220kV GIS-GENERAL ARRANGEMENT PLAN & SECTIONS-OPTCL ERSAMA

400/220kV GIS SUBSTATION AT ERSAMA, ODISHA & 400kV AIS FEEDER BAY EXTENSION AT DUBURI, ODISHA

220kV GIS Indoor Layout, Plan & Section

COMPLIANCE SHEET

GIS HALL PLAN

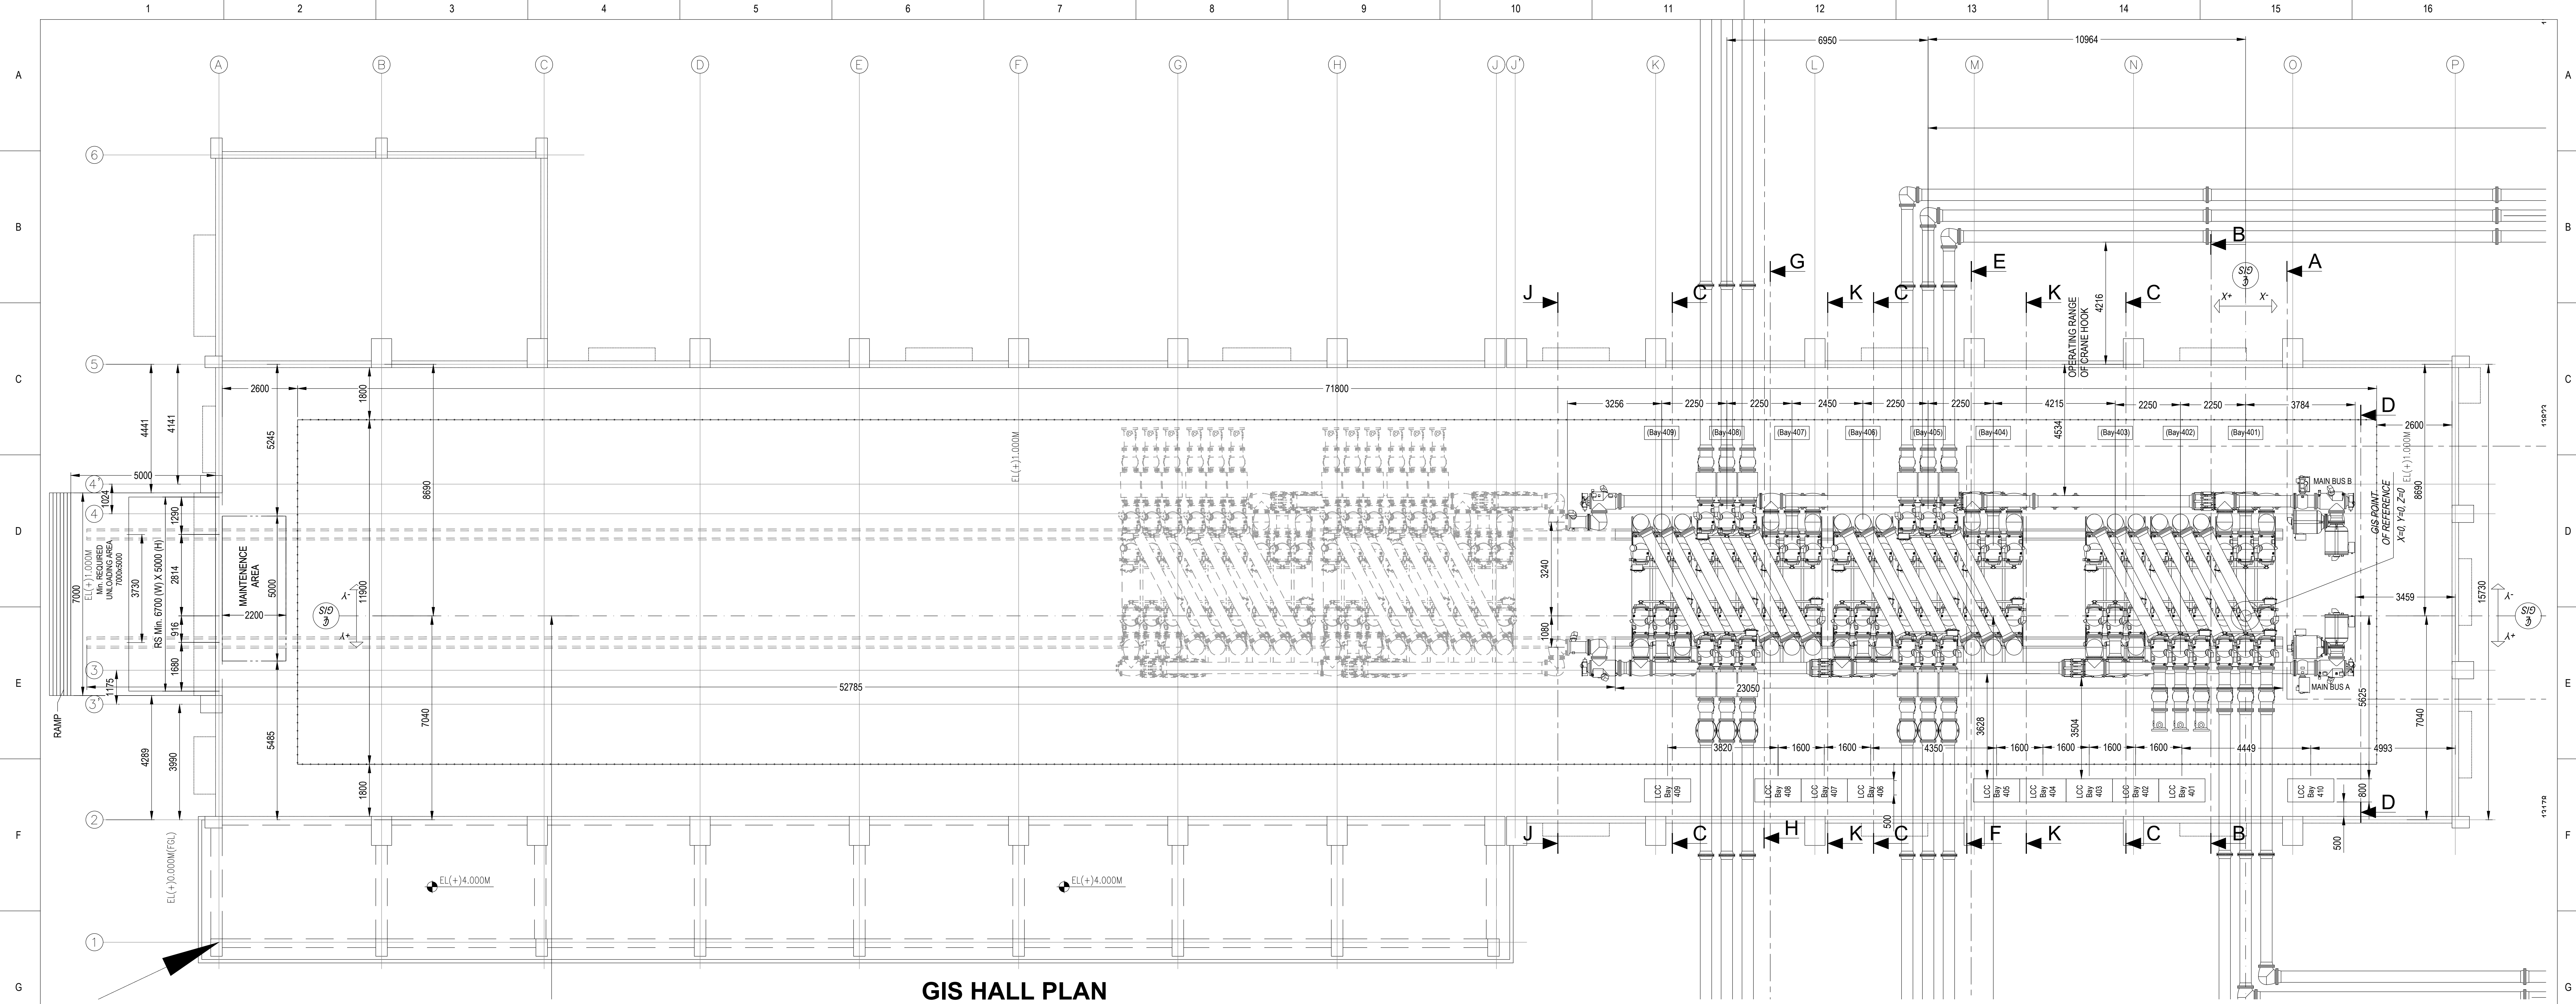
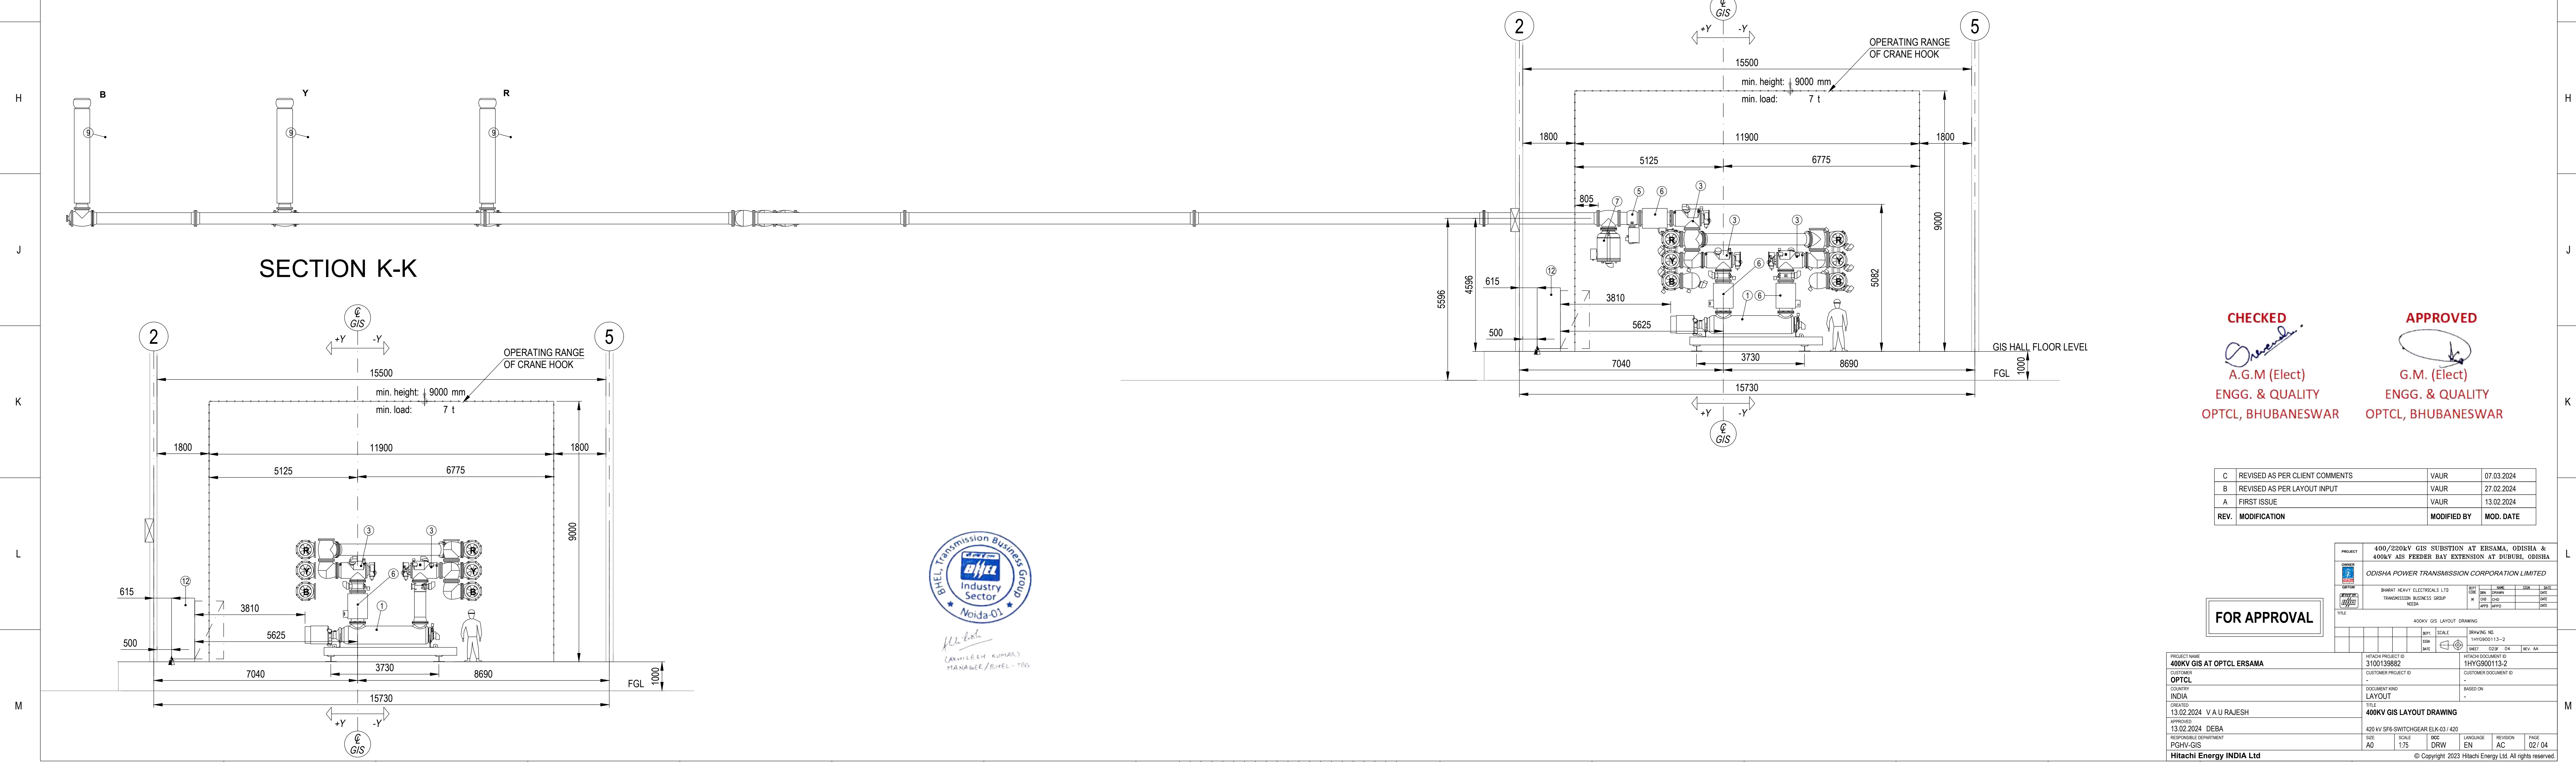
A platform shall be provided along the entire length of the GIS to facilitate easy access to key areas for maintenance purpose.

DWG TITLE: STRUCTURE LOADING DIAGRAM FOR 400/220KV GIS SUB STATION AT ERSAMA

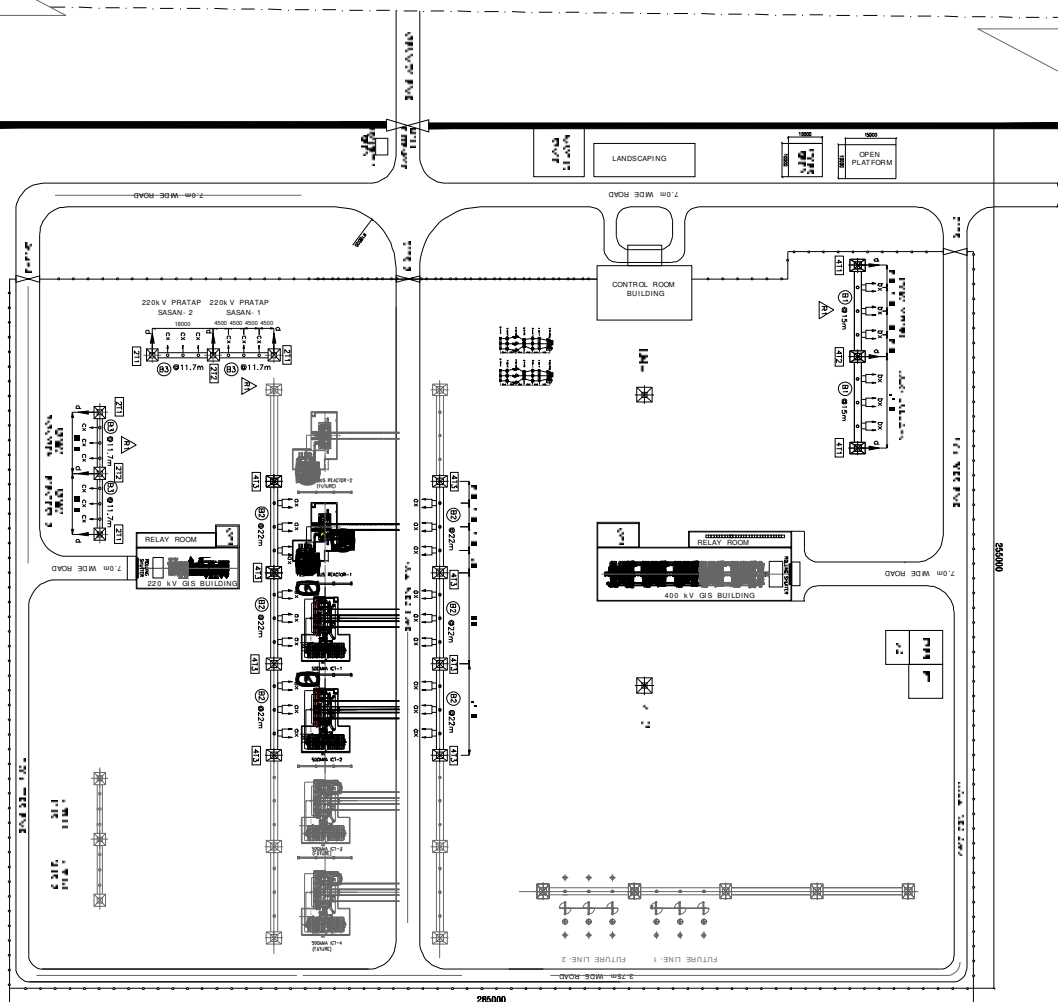
Sl.No.	Customer Comments	BHEL Clarification/ Compliance
OPTCL comments vide mail dated 21.04.23		
1	The following shall be adopted for the substation structures: 411 and 412 shall be low gantry type i.e. @15m 413 shall be @22m 211 & 212 shall be of low gantry type i.e. @10.5m or 11.7m - cx shall be Single ACSR Zeon - The DSLP may be re-checked as per the new structures. All other structures shall be as per your drawing no-TB-1-420-316-006 shall remain same.	Noted & incorporated in revised drawing. Revised DSLP will be submitted shortly.
OPTCL comments vide D3 portal dated 28.03.23		
2	The tension per phase for 400kv (cx), 220kv (cx) and Shield Wire (d) shall be considered and mentioned in the drawing.	Forces bx & cx are on the terminal take-off gantries of 400KV & 220kv respectively & there will be stringing only on the line side. Line stringing, being a slack span, the Short Circuit tension is not considered and the take-off gantries are designed only for the Normal tension. Normal tensions have been considered as per the contract specification clause no. 2.2, Chapter-L7. "Terminal line take off gantries shall be designed for a minimum conductor tension of four metric tons per phase for 400KV and two metric tons per phase for 220KV & 132 kV." Similarly for Shield wires (d) Short Circuit forces are not applicable. Thus we request OPTCL to accept the proposed loading.

3	Two nos. of 30m LMs have been considered in the drawing. The BOQ has Three nos. 40m LMs.	BILL proposes to provide lattice structure type 2 nos. 50m High LMs for Lightning protection of Sub-station. This item is covered in the contract BOQ item sl. no. 20.1 and will be billed by BILL in M1. 40m High Monopole Lighting cum Lightning Mast are not covering the entire area for Lightning protection. Further, the proposed 50m High LM will be used not only for Lightning protection, but also for Sub-station lighting as platforms will be provided for mounting lights at 12.5m & 25m levels. This is as per the contract specification clause no. 2.2, Chapter-L7. 40m High monopoles will be provided only in case of illumination requirement of Sub-station.
4	The revised drawing considering the above may be submitted with signature of M/s BHFI in the pdf file (not scanned)	Noted. Digitally signed revised drawing submitted for final approval.
